Subject: **CORRECTING BLACK HORIZONTAL STRIPE NOISE**

Model: **BVM-8044QD, BVM-8045QD**
PVM-8040, SSM-8040

Figure 1

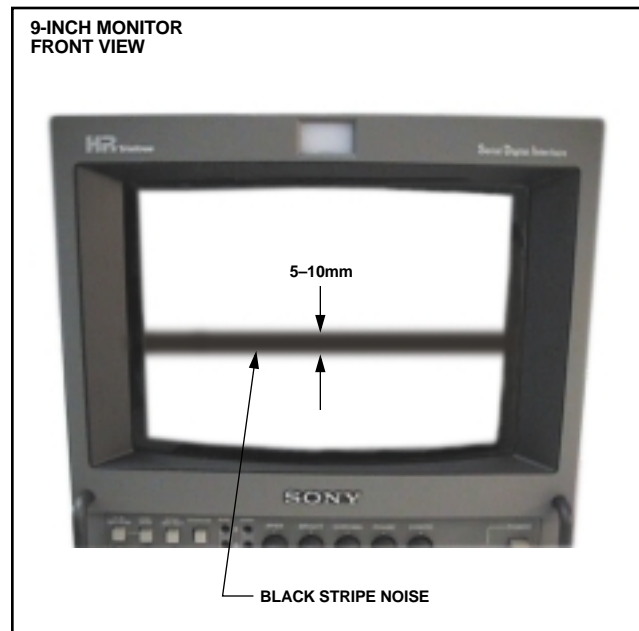
If the high voltage cable retaining disk touches inductor L506 on the D board, 5 to 10mm wide black stripe noise may periodically appear on the 9-inch monitor screen for 0.1 to 0.2s. (See Figure 1.)
